<b>Office Action Summary</b>	<b>Application No.</b> 10/581,755	<b>Applicant(s)</b> HE ET AL.	
	<b>Examiner</b> THINH T. NGUYEN	<b>Art Unit</b> 2818

### **DETAILED ACTION**

1. This is in response to Applicant's Amendment filed April 20<sup>th</sup> 2010

ZHU 994 DISCLOSURES

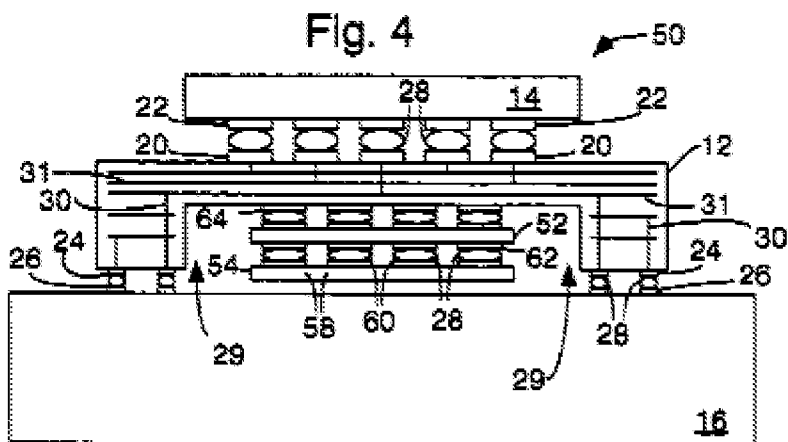
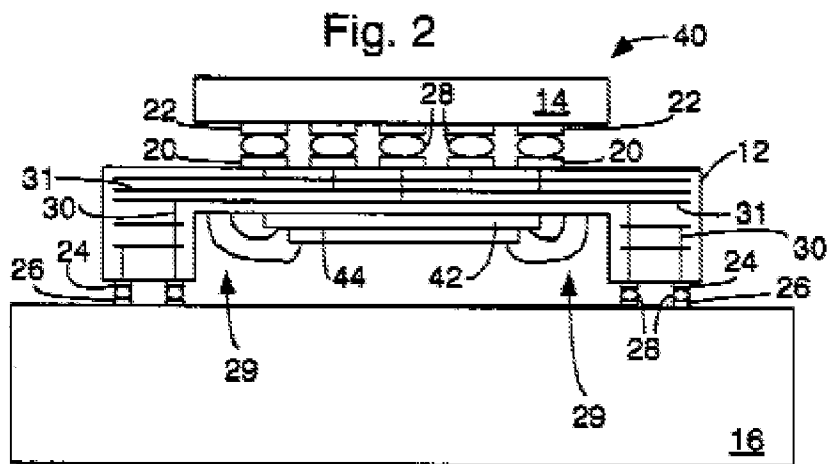
With regard to claim 1, Zhu 994 discloses (the abstract,fig 2,fig4) a microelectronic device comprising:

a package substrate having a first side and an opposing second side;( element # 16, fig 2,fig4 ) a package connector at the second side of the package substrate and a board coupled to the package connector;( fig 2 fig 4, element #12) a microprocessor adjacent to the first side of the package substrate; ( fig 2,fig 4 chip 14 ) and a memory device adjacent to the second side of the package substrate ( fig 2, elements #42,#44, fig 4,elements # 52,54,column 3 lines 40-55,column 4 lines 15-35 ) wherein the package substrate is electrically coupled to at least one of the microprocessor and the memory device and wherein the memory device is located in a cavity ( claim 1 ,fig 2,fig 4) defined by the package connector, the package substrate, and the board..

With regard to claim 4 , Zhu 994 discloses ( fig 2, fig 4) a microelectronic device wherein the memory device is disposed on a land side of the substrate ( note that Zhu 994 discloses a substrate ( inherent to fig 2 ,fig 4, element # 16 that has land side conductive pads and conductive traces on top )

With regard to claim 7, Zhu 994 (the abstract, fig 2, fig 4) discloses a microelectronic device further comprising a die including one selected from the group including a memory device, a memory controller, an application specific integrated circuit (ASIC), a graphics processor, a signal processor, a radio transceiver, and a combination thereof.( not that Zhu discloses that his microelectronics device can has three chip , one of the chip can be an ASIC or a microprocessor and the other two can be various memory devices ( column 2 lines 10-67)

**FIG. 2**  
**Prior Art**

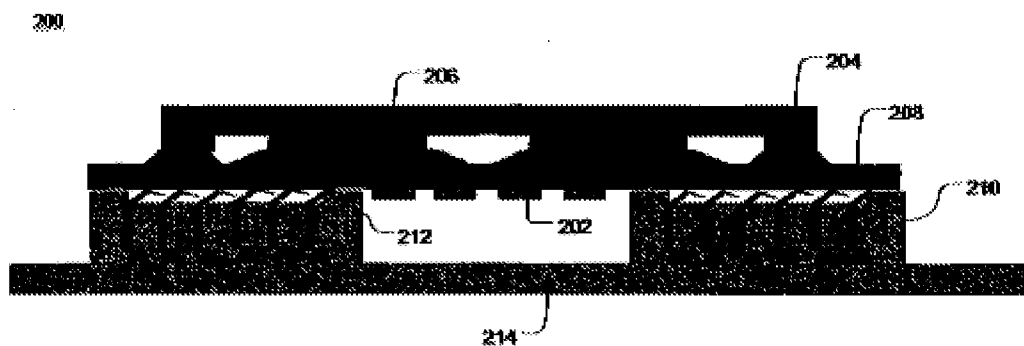
With regard to claim 1, the AAPA ( fig 2 of the present application ) disclosed all the invention of claim 1 including a package substrate ( fig 2 # 214 ) having a first side and an opposing second side; a package connector at the second side of the package substrate ( fig 2 # 210 ) and a board ( fig 2 #208) coupled to the package connector) a microprocessor ( fig 2 #206 , paragraph [0009] of the present Application Specification ) adjacent to the first side of the package substrate; and a cavity defined by the package connector, the package substrate, and the board..(fig 2 of the present Application)

Not disclosed in the AAPA is the limitations wherein the package has a memory device adjacent to the second side of the package substrate wherein the package substrate is electrically coupled to at least one of the microprocessor and the memory device and wherein the memory device is located in the cavity defined by the package connector, the package substrate, and the board..

Note that the modification using the Gilmore 917 disclosures can be easily realized in fig 2 of the AAPA by putting the memory devices on the opposite side of the board similar to the capacitors inside the cavity of the AAPA device in fig 2.

With regard to claim 4, the combined AIPA in view of Gilmore 917 disclosed a microelectronic device wherein the memory device is disposed on a land side of the package substrate ( the AIPA fig 2 of the present Application )

With regard to claim 9, the AAPA (fig 2 of the present Application) discloses the use of a head spreader (fig 2, # 204, paragraph [0009] of the specification of the present Application)

**FIG. 7**

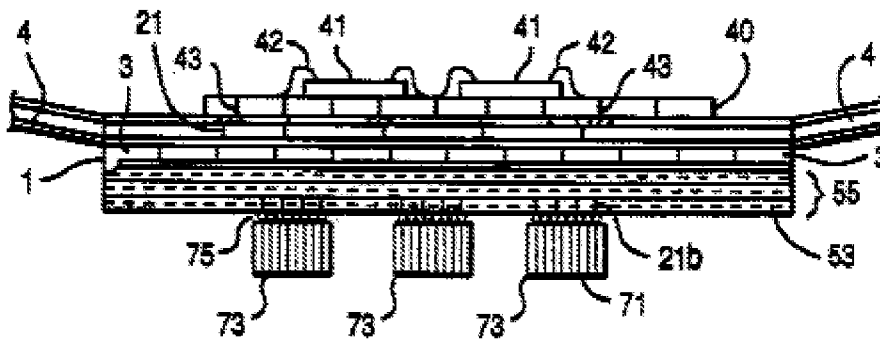
With regard to claim 7, Gilmour 917 discloses ( fig 7,fig 9,fig 10,fig 11 ) a microelectronic device further comprising a die including one selected from the group including a memory device, a memory controller, an application specific integrated circuit (ASIC), a graphics processor, a signal processor, a radio transceiver, and a combination thereof.( column 7 lines 54-60)

FIG. 11

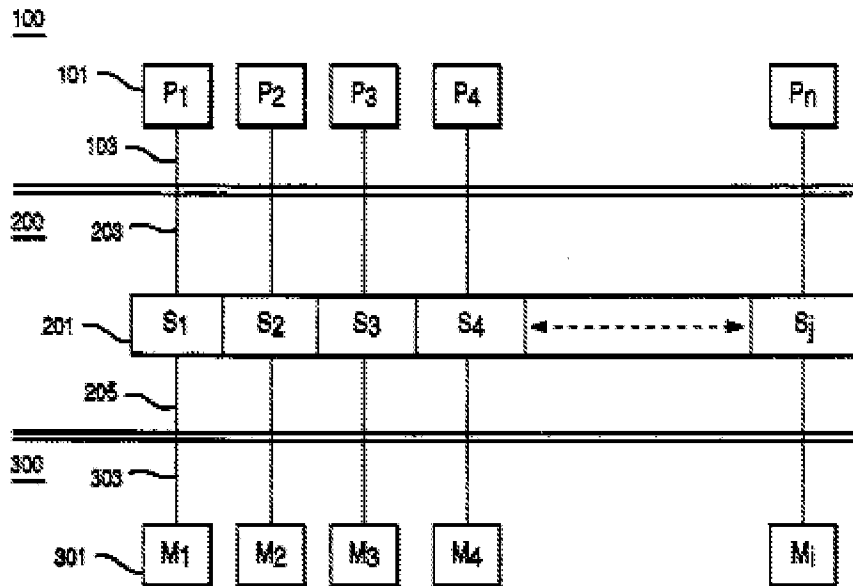
With regard to claim 2, Gilmore 917 disclosed the incorporation of the cross point switching devices S1 to Sj (in fig 11) into the package that perform the function of a memory controller (column 7 lines 9-55)

With regard to claim 5, Gilmour 917 discloses (fig 8, fig 10,fig 11 ) a microelectronic device further comprising a third die including a second microprocessor, a fourth die including a third microprocessor, and a fifth die including a fourth microprocessor.

With regard to claim 6, Gilmour 917 discloses (fig 8, fig 10, fig 11) a memory device electrically coupled by one selected from the group including a wire bond electrical interconnect, a flip-chip ball grid array electrical interconnect, a lead frame interconnect, and a combination thereof.
